Office Action Summary	Application No. 10/772,460	Applicant(s) MEYER, SIEGFRIED	
	Examiner Vinh T. Luong	Art Unit 3682

5. Claims 1-5 are rejected under 35 U.S.C. 102(b) as being anticipated by Anthony (US Patent No. 2,217,721).

ATTACHMENT

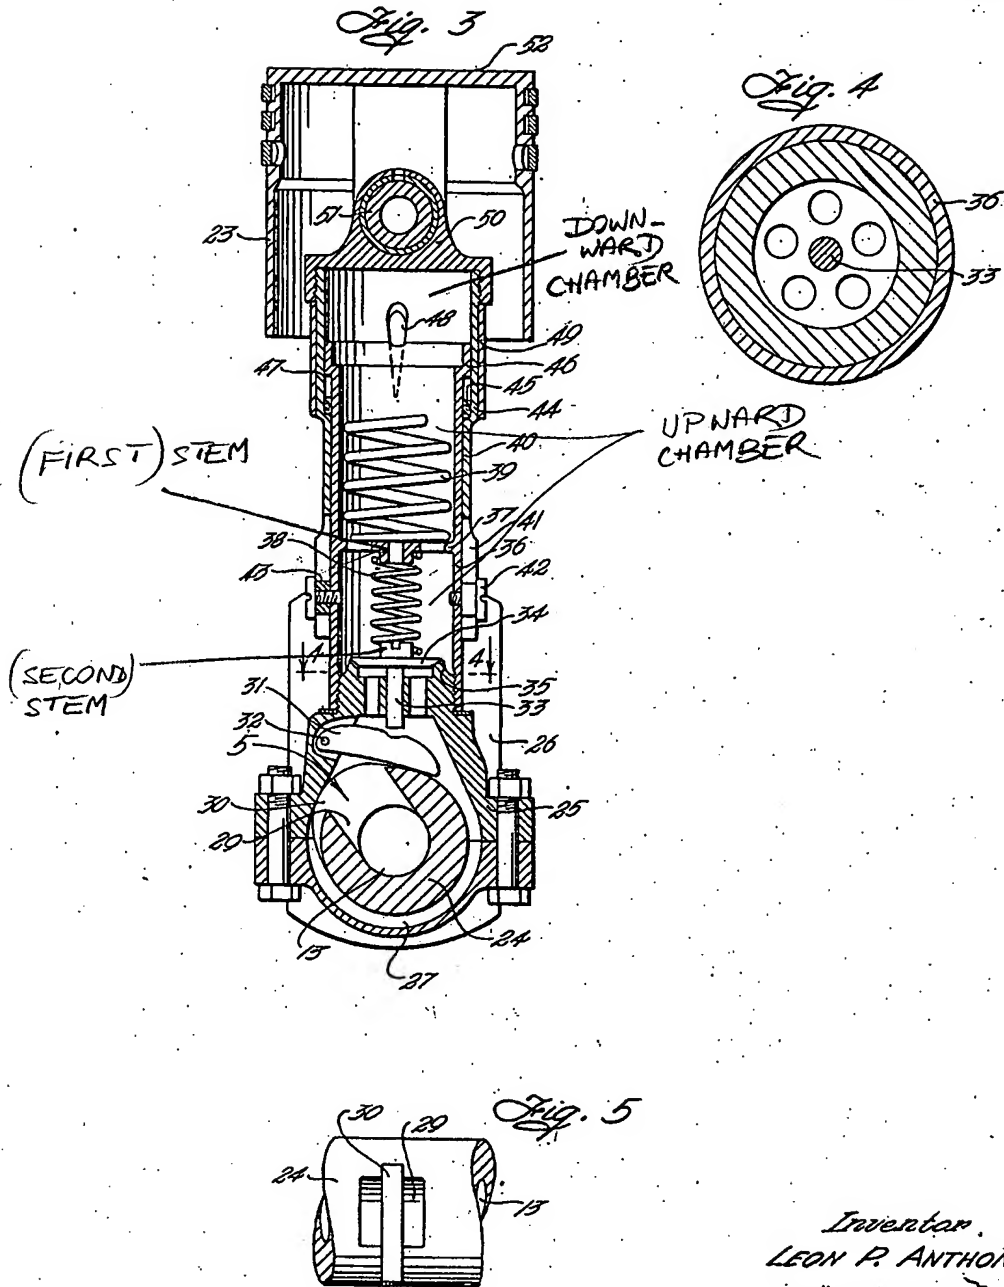
a first coupling member 50, 49, 40 pivoted to said piston 23, said first coupling member comprising a downwardly extended receiving open chamber (unnumbered in Figs. 1 and 3. See Attachment or "Att.") defined in a downwardly extended hollow body 49 thereof and an inner tube 40 suspended in said downwardly extended receiving open chamber inside said downwardly extended hollow body 49;

a second coupling member 25, 36 pivoted to said crankshaft 24, said second coupling member 25, 36 comprising an upwardly extended hollow body 36 inserted into the downwardly extended receiving open chamber (Att.) and axially movably sleeved onto said inner tube 40, and an upwardly extended receiving open chamber (Att.) defined in said upwardly extended hollow body 36 thereof and adapted to receive said inner tube 40; and

Regarding claim 2, said first coupling member 50, 49, 40 comprises a (first) stem (Att.) coaxially suspended inside said inner tube 40; said second coupling member 25, 36 comprises a (second) stem (Att.) suspended in said upwardly extended receiving open chamber (Att.) and aimed at the (first) stem (Att.) of said first coupling member 50, 49, 40; said axially compressible spring member 38 has two ends respectively fastened to the (first) stem (Att.) inside said first coupling member 50, 49, 40 and the (second) stem (Att.) inside said second coupling member 25, 36.

Regarding claim 4, said stop means comprises a first annular stop flange 44 radially inwardly protruded from a bottom end of the hollow body 49 of said first coupling member 50, 49, 40 and disposed in contact with the periphery of the hollow body 36 of said second coupling member 25, 36, and a second annular stop flange 46 radially outwardly protruded from a top end of the hollow body 36 of said second coupling member 25, 36 and disposed in contact with an inside wall of the hollow body 49 of said first coupling member 49. See Fig. 3 and page 2, right column, lines 50-74.
